Cape Peron Ocean Outlet Metropolitan Water Supply, Sewerage and Drainage Board.

Report and Recommendations
by the Environmental
Protection Authority.

Department of Conservation
and Environment, Western
Australia
Bulletin 114
May 1982

Figure 1

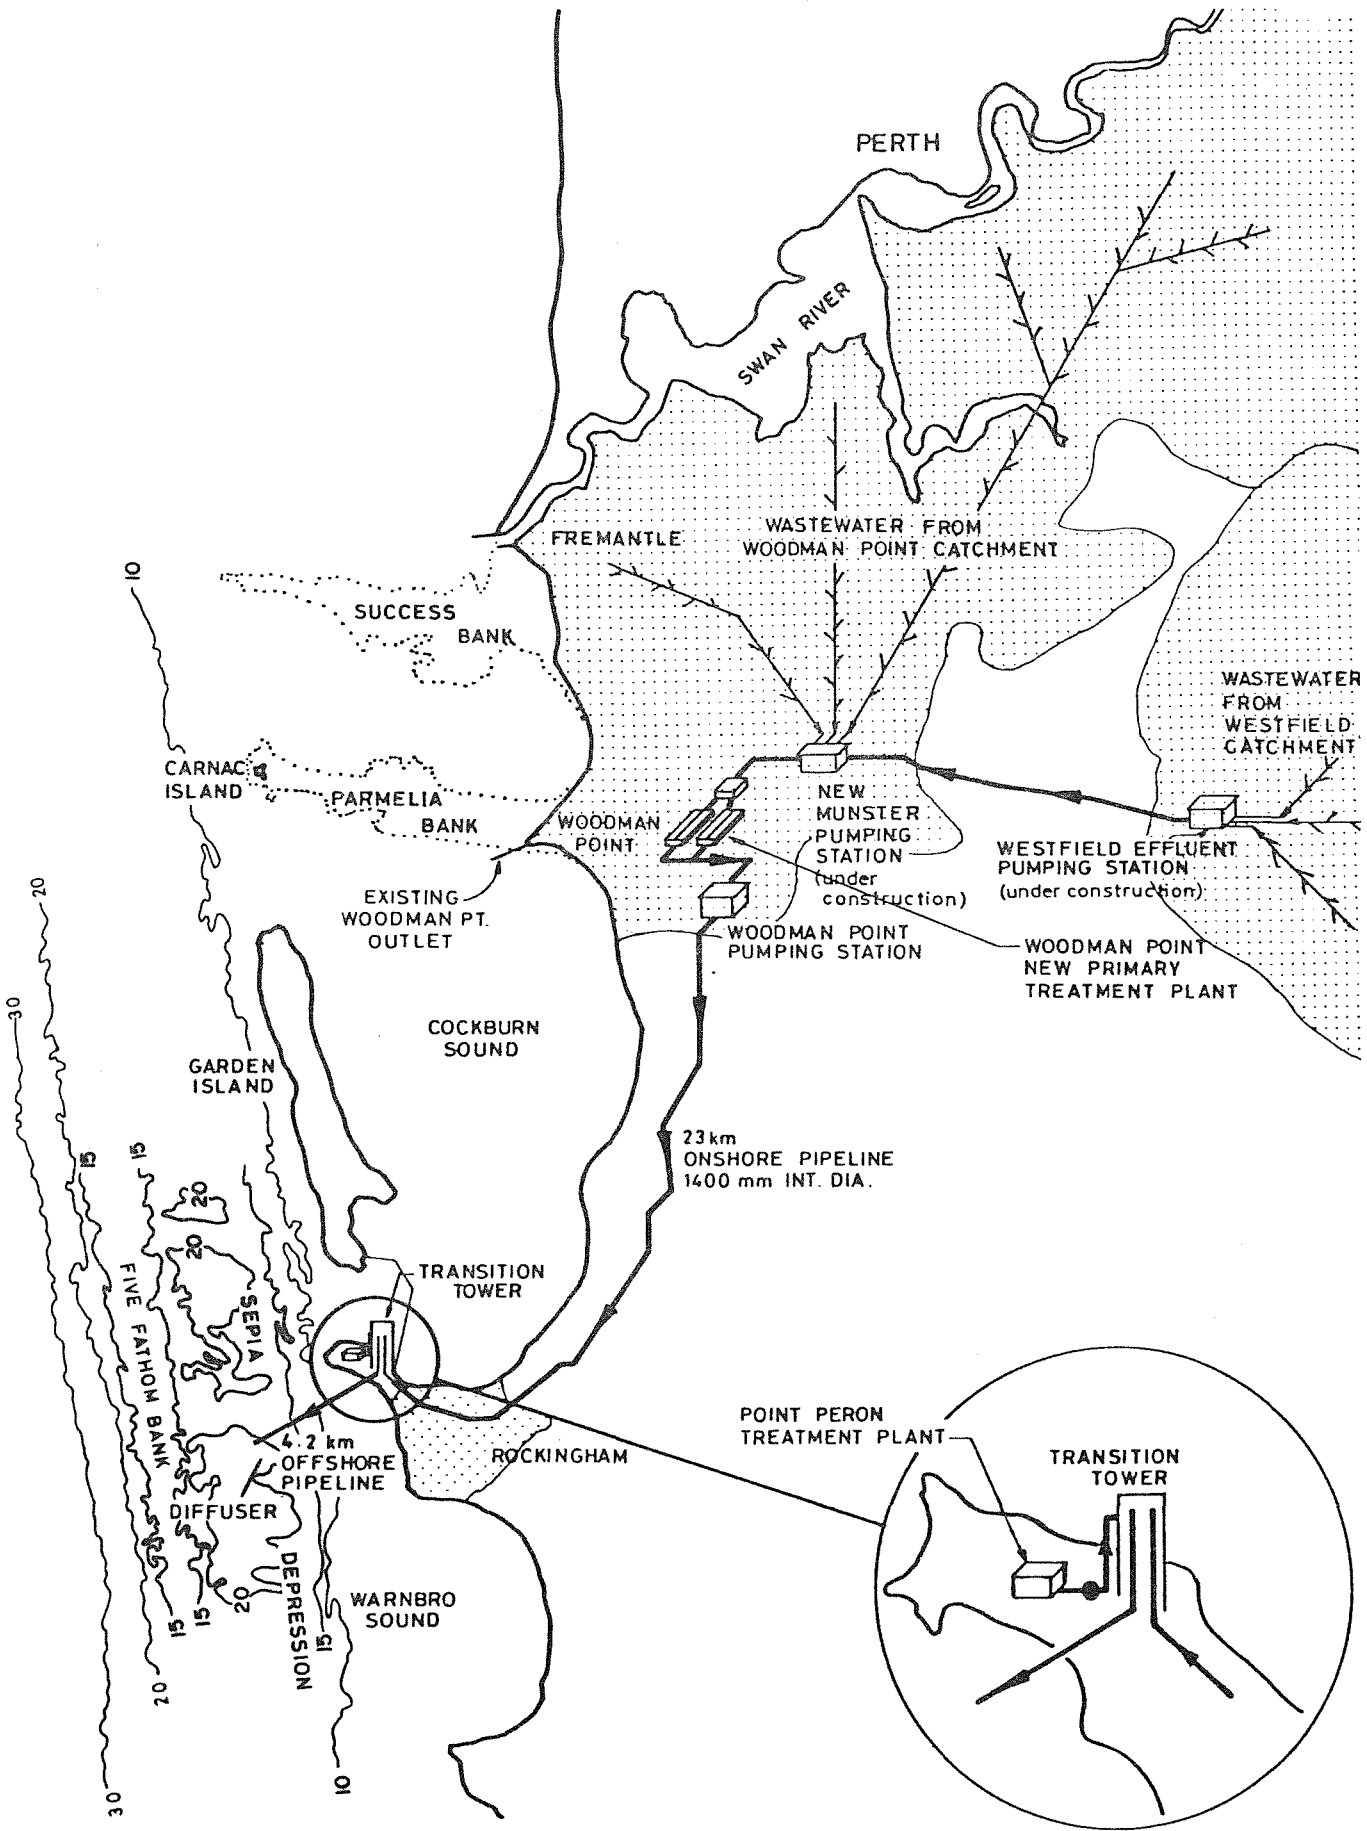
There were some public criticisms of the ERMP. A large number of people were critical of the figures S.1 and 3.1 because the offshore pipe was not shown to scale, even though the figure was clearly labelled schematic and the length of the pipe is written next to it. The scale bar on figure 6.7 was incorrect although the drawing is correct and fully to scale.

Figure S.1 is reproduced in this report (figure 1) with the pipeline shown at the correct relative length.

Figure 2

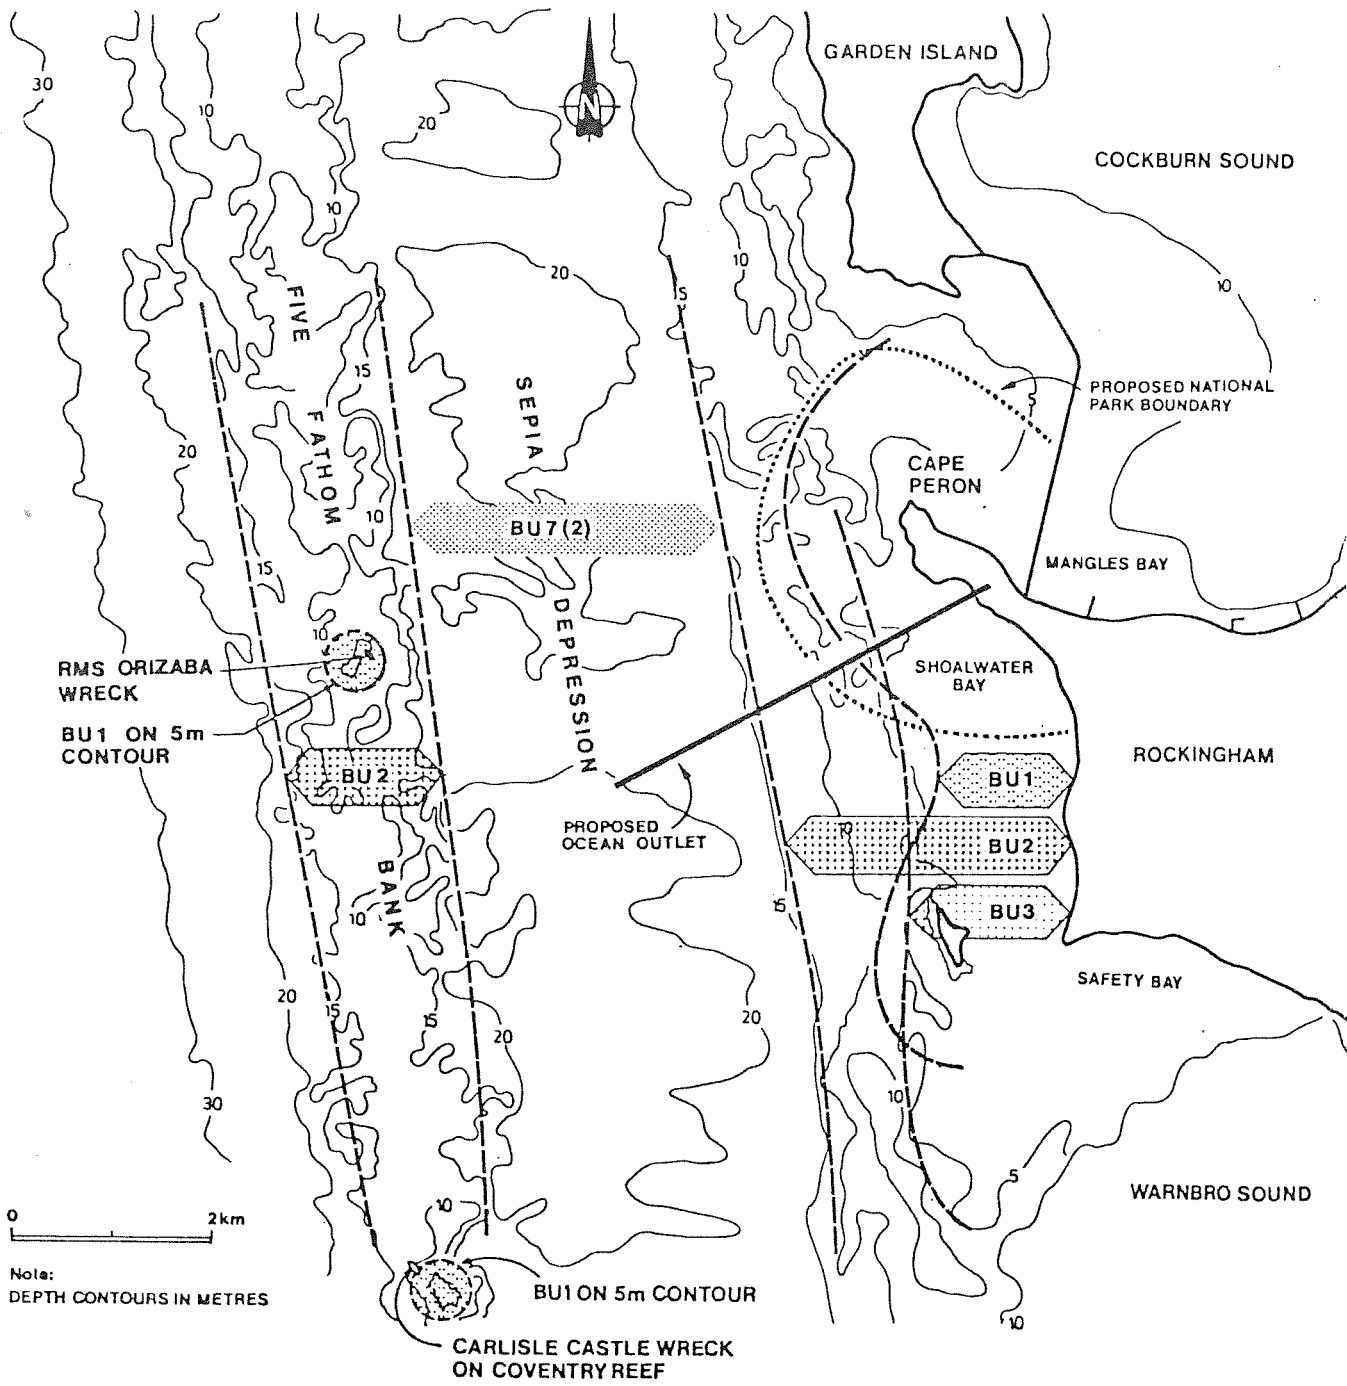
Further investigation indicated that the four beneficial use classifications shown on Fig. 6.1 (Figure 2 in this report) would adequately define the most stringent criteria likely to apply in any area. i.e. Beneficial Use Numbers 1, 2, 3 and 7 were considered to be critical for this area.

The EPA accepts this as a reasonable approach in lieu of a more formalised system which is yet to be developed. However, it is necessary to point out that the beneficial use areas may be subject to changes at some future date.
